ATTACHMENT B-1

PROPOSED CHANGES TO APPENDIX A, TECHNICAL SPECIFICATIONS, OF FACILITY OPERATING LICENSES NPF-37 AND NPF-66 BYRON NUCLEAR POWER STATION, UNITS 1 AND 2

ATTACHMENT B-2

**PROPOSED CHANGES
TO APPENDIX A, TECHNICAL SPECIFICATIONS,
OF FACILITY OPERATING LICENSES
NPF-72 AND NPF-77
BRAIDWOOD NUCLEAR POWER STATION, UNITS 1 AND 2**

Affected page: 5-4

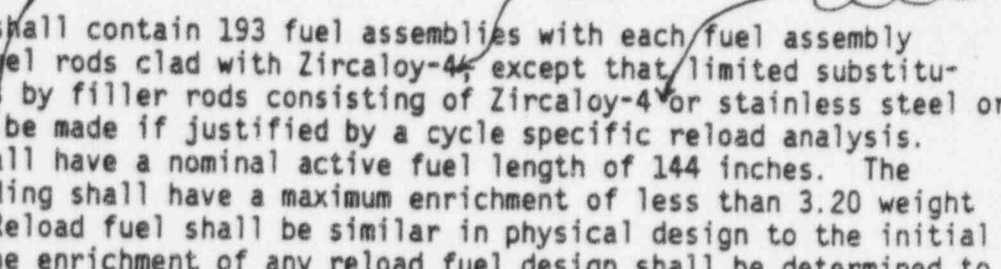
5.3.1 The core shall contain 193 fuel assemblies with each fuel assembly containing 264 fuel rods clad with Zircaloy-4; except that, limited substitution of fuel rods by filler rods consisting of Zircaloy-4 or stainless steel or by vacancies may be made if justified by a cycle specific reload analysis. Each fuel rod shall have a nominal active fuel length of 144 inches. The initial core loading shall have a maximum enrichment of less than 3.20 weight percent U-235. Reload fuel shall be similar in physical design to the initial core loading. The enrichment of any reload fuel design shall be determined to be acceptable for storage in either the spent fuel pool or the new fuel vault. Such acceptance criteria shall be based on the results of the CRITICALITY ANALYSIS OF BYRON AND BRAIDWOOD STATION FUEL STORAGE RACKS.

ComEd proposes to revise Technical Specification 5.3.1, Fuel Assemblies, to allow use of an alternate zirconium based fuel cladding, ZIRLO. Limited substitution of fuel rods by ZIRLO filler rods would also be permitted. Editorial changes are also proposed.
